**STAFF REPORT:** 06/11/2025 **REVISED**  
**APPLICATION NUMBER:** HDC2025-00192  
**VIOLATION NUMBER:** 25-1005  
**ADDRESS:** 3751 LESLIE

**SCOPE:** REPLACE HISTORIC WINDOWS, MULTIPLE EXTERIOR ALTERATIONS

*Photo from real estate listing, 09/2024, 3751 Leslie*

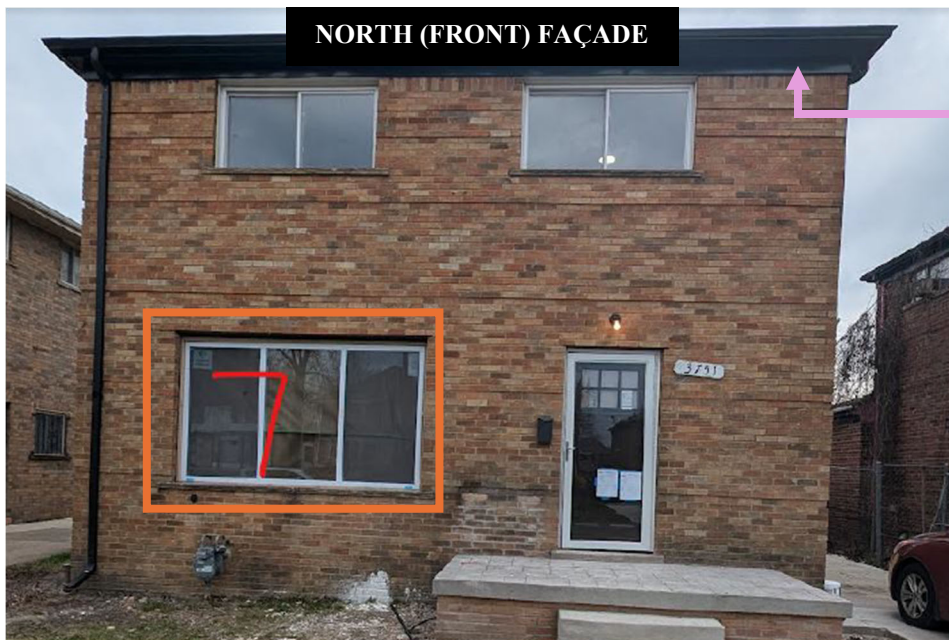
- The front façade, second level historic steel windows were replaced sometime between 2009 and 2011 from a previous owner, without the approval of the HDC.

*Photo from real estate listing, 09/2024, showcasing the historic band of trim, soffits, and fascia.*

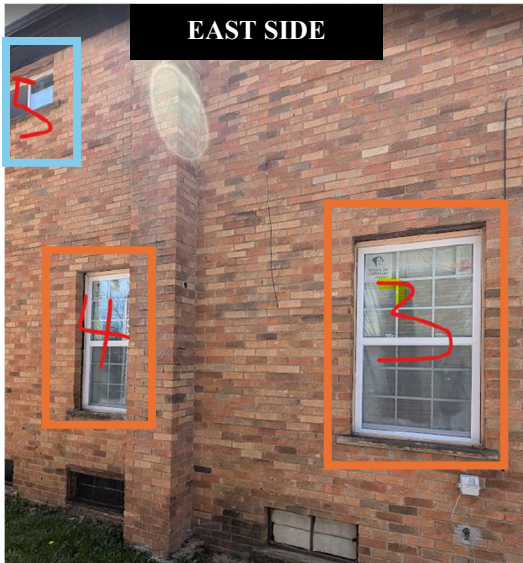
- Note that the black, aluminum wrapping around the trim/soffits/fascia, also installed without the approval of the HDC.

*Staff photo, 05/27/2025*

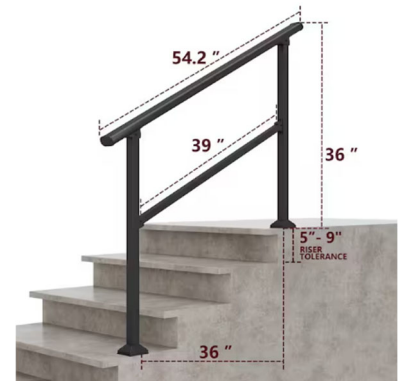
- Though the previous porch seemed to be in a state of deterioration, the removal of the historic brick planter box does not meet the standards. As stated in the [NPS Standards for Rehabilitation](#): “deteriorated historic features shall be repaired rather than replaced. Where the severity of deterioration requires replacement of a distinctive feature, the new feature shall match the old in design, color, texture, and other visual qualities and, where possible, materials.”

- Rebuild historic brick planter box in-kind, with staff to review and approve
- Staff is to review foundational planting scope
